## **Skyline Aggregate Transportation Study Trip Generation and Signal Warrant Review**

**Dec 3, 2025. Headway Transportation**

**April 4, 2026. LSC Transportation Consultants, Bill Suen TE**

A peer review of the *Updated Transportation Technical Study for Skyline Aggregates* dated December 3, 2025 by GCW Engineers and Surveyors was conducted by LSC Transportation Consultants INC. The findings from the review are documented in this memo.

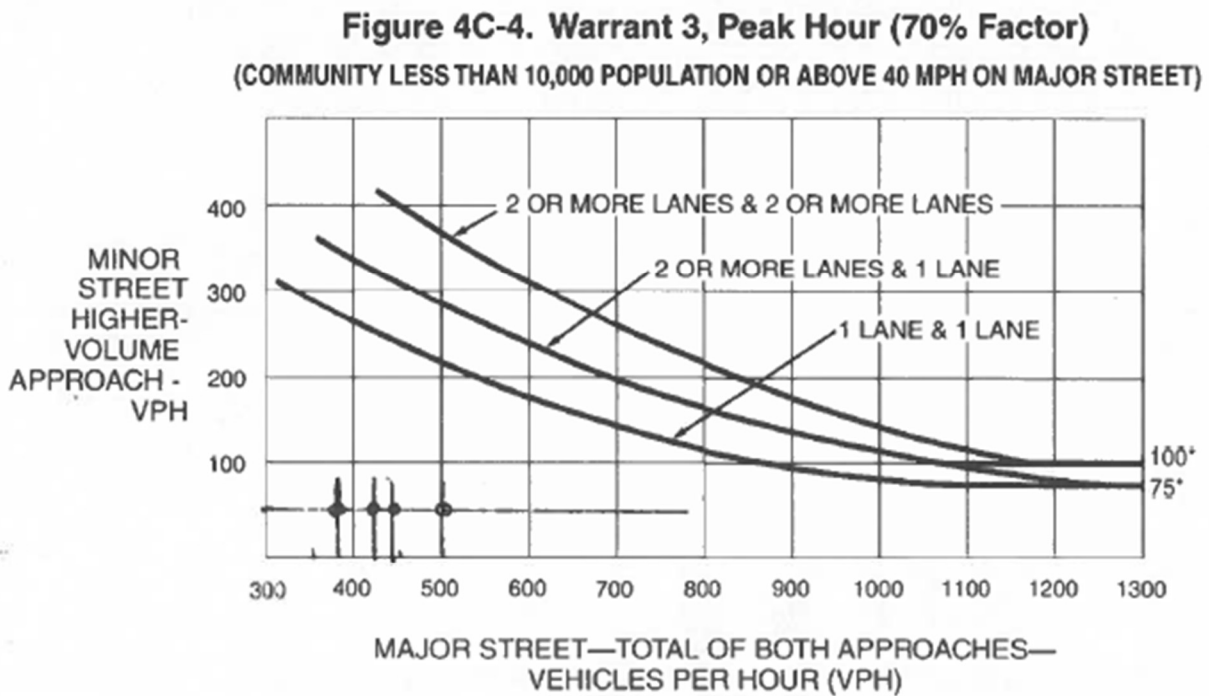
Volumes for each hour of a 24-hour design day are typically evaluated to determine if conditions are met for any 8 of those hours. The study applies only the four peak hours assuming that the remaining 20 hours of the day do not exceed the four selected hours for which data was collected and adjusted for future conditions. A 24-hour roadway volume count could have been performed to confirm the assumption. Although the AM and PM commute periods typically account for the peak traffic, some roadways tend to peak midday.

Based on the assumption that the four hours of data collected are the highest four hours of traffic volumes over the course of the day, and since neither of the threshold columns are exceeded, warrant 1 is not met. However, it is recommended to conduct a 24-hour roadway count to confirm this assumption.
